Figure 2-4 San Lorenzo River Multipurpose Path

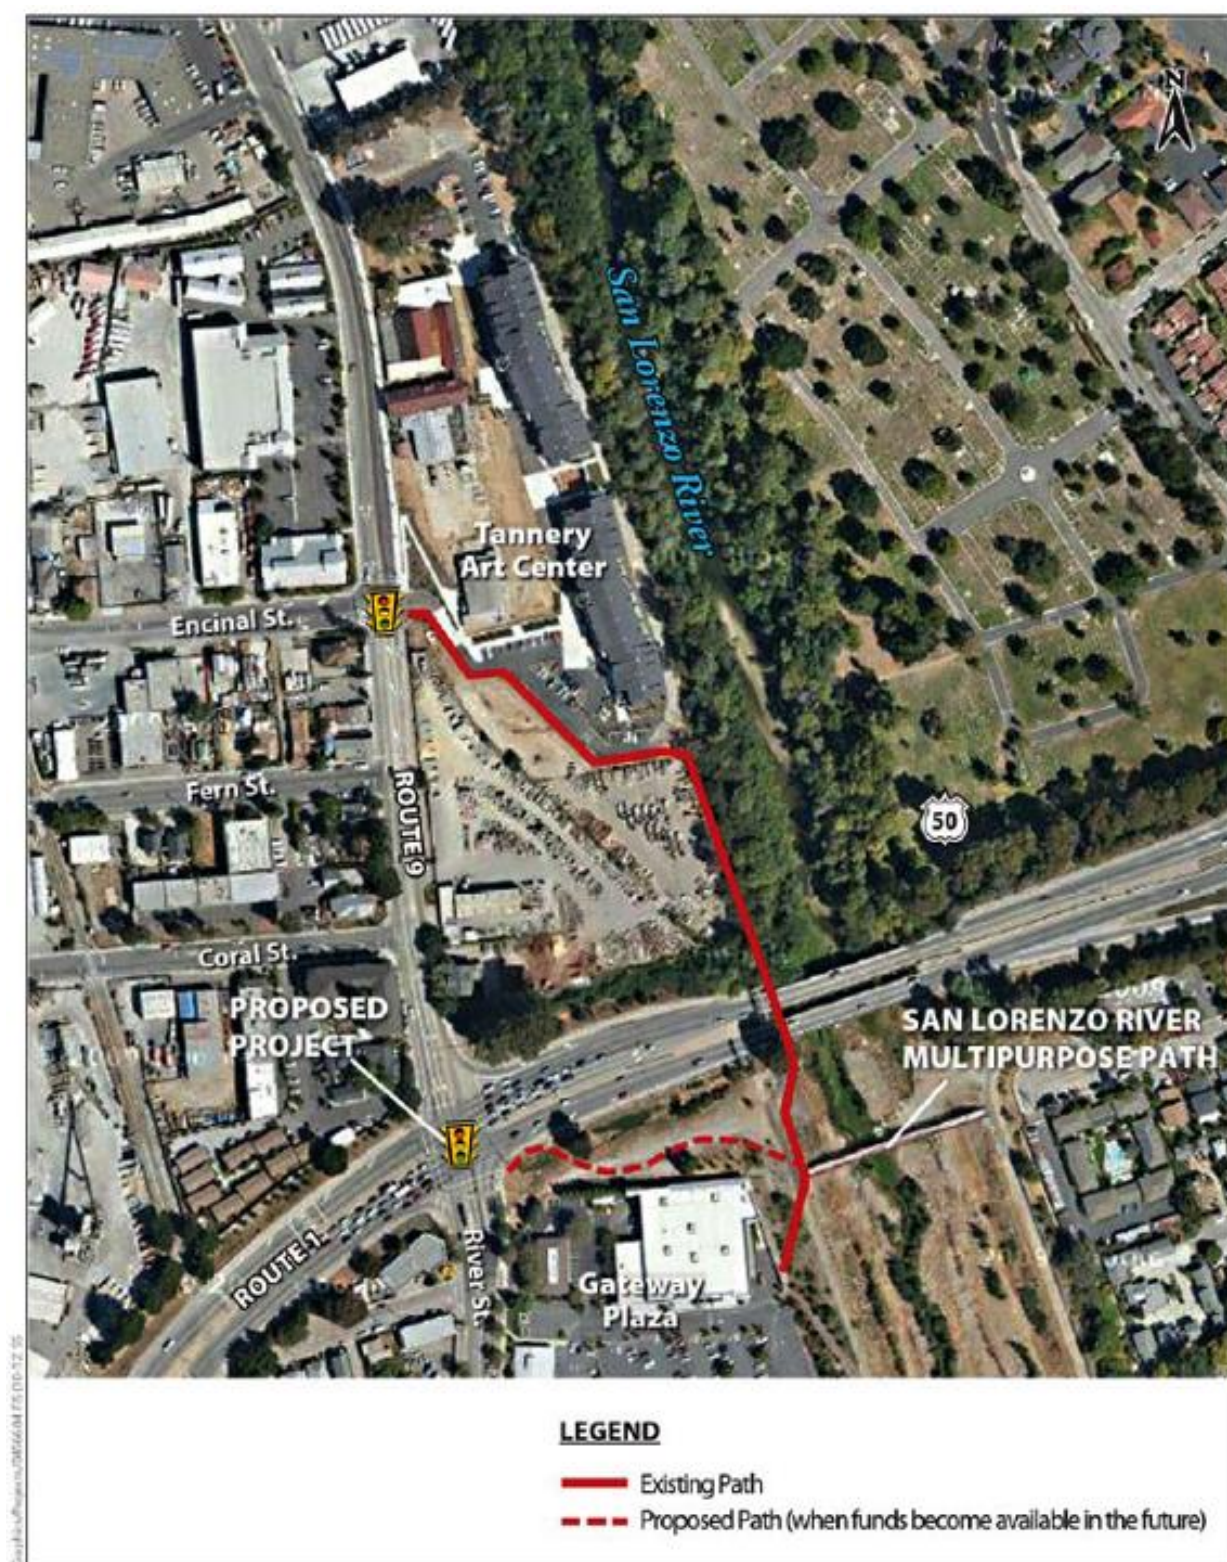
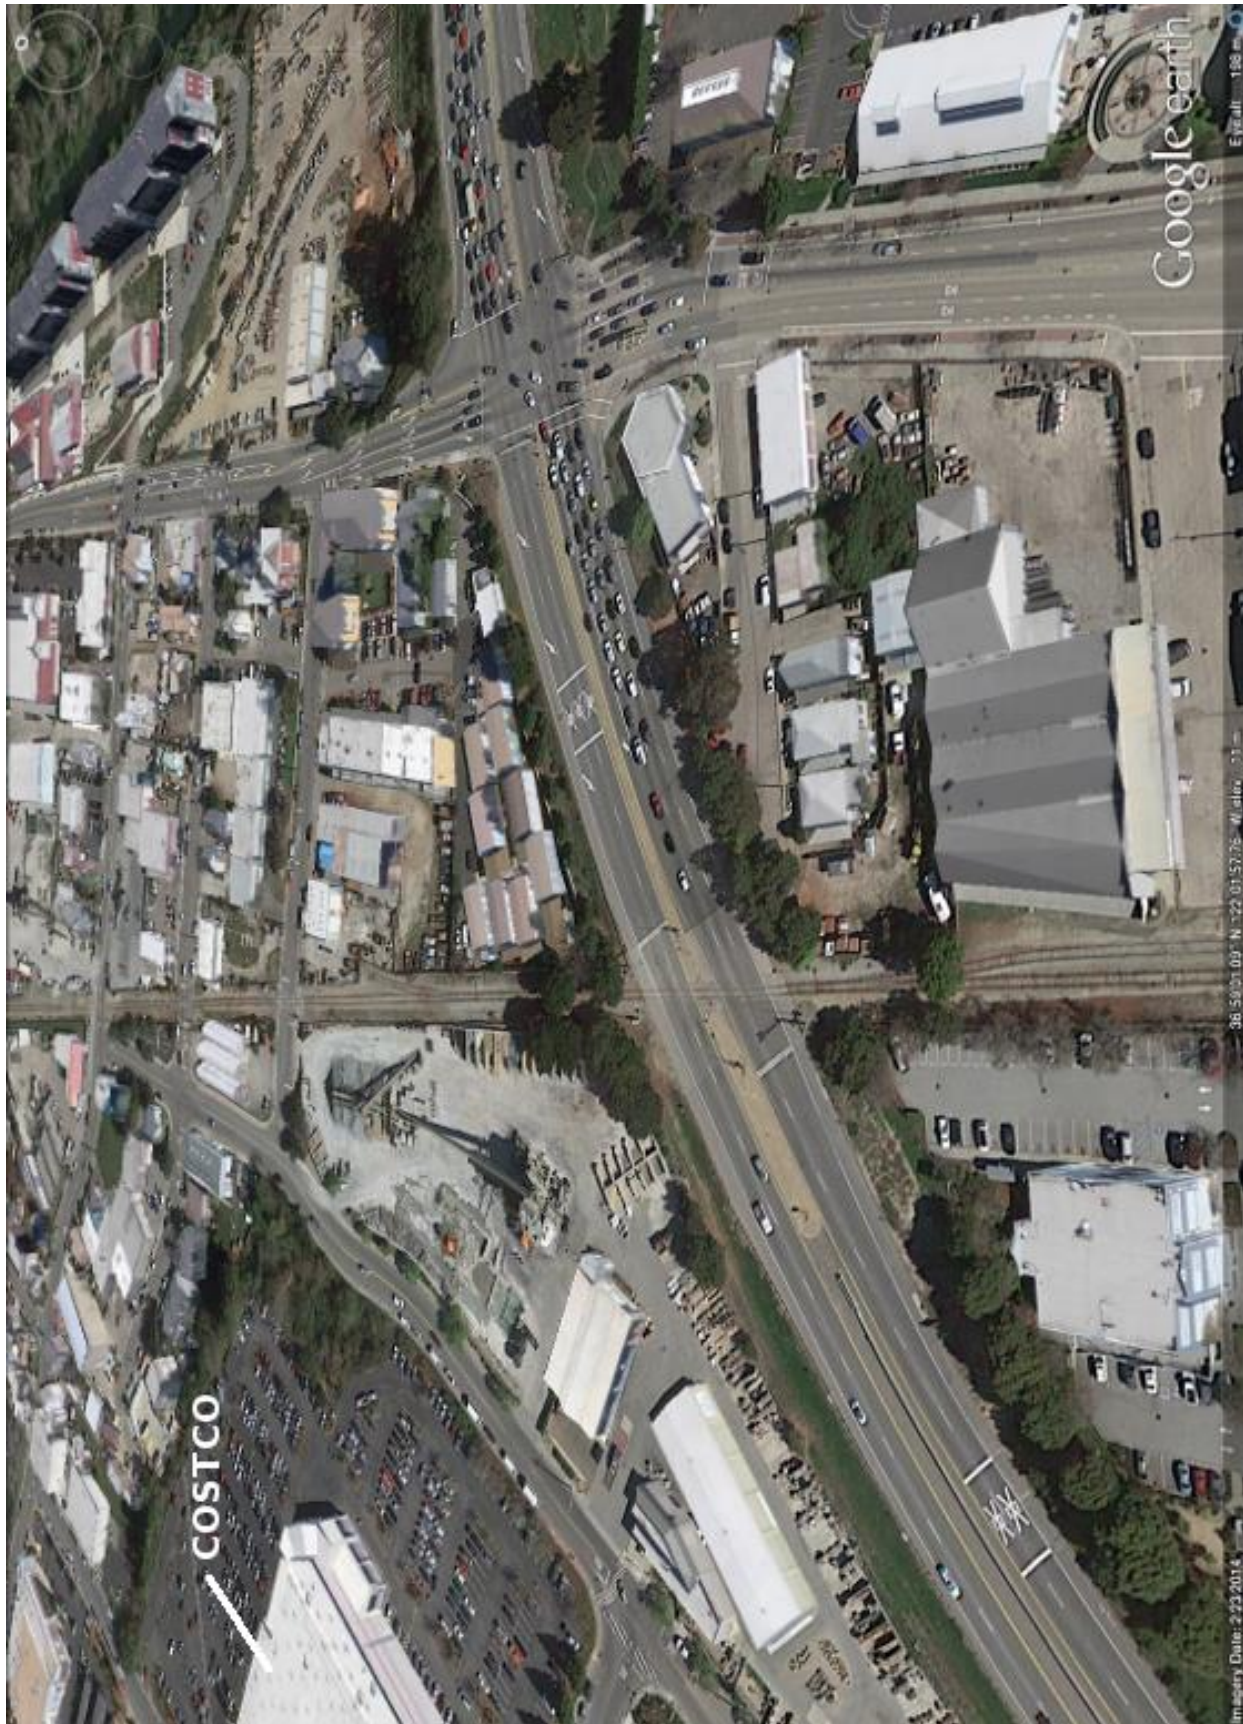
The discussion of the needs of bicyclists is not adequate. While the new path under the bridge from the river levee south of the intersection does provide an alternate route for bicyclists to cross the highway, it is a longer route. (See Fig. 2-4 on page 39 of your document, a copy of which is attached to this letter.) It is not well signed, and a bicyclist heading north on River Street or south on Highway 9 would naturally cross the intersection, making use of the signal. It would help if there were bike lane indicators, and ideally green pavement, to guide the bicyclist across the intersection. Furthermore, Fig. 2-4 shows a proposed path (dashed) that inexplicably is not included in the project, but is proposed to await available funds. It would seem that now is the appropriate time to grade and pave this path and include it.

Response to Comment #45-2: Your comment states that the alternate route for bicyclists, along the San Lorenzo River Multipurpose Path, is not well signed so bicyclists traveling north naturally take the surface streets. The City will explore an appropriate location to add signage along River Street to direct people to the San Lorenzo Multipurpose Path. Note that this is a local matter and outside Caltrans authority.

The purpose and need for the proposed Route 1/9 Intersection Improvement project is different from the planned bicycle path project. The City will continue to pursue these opportunities and separate improvements.
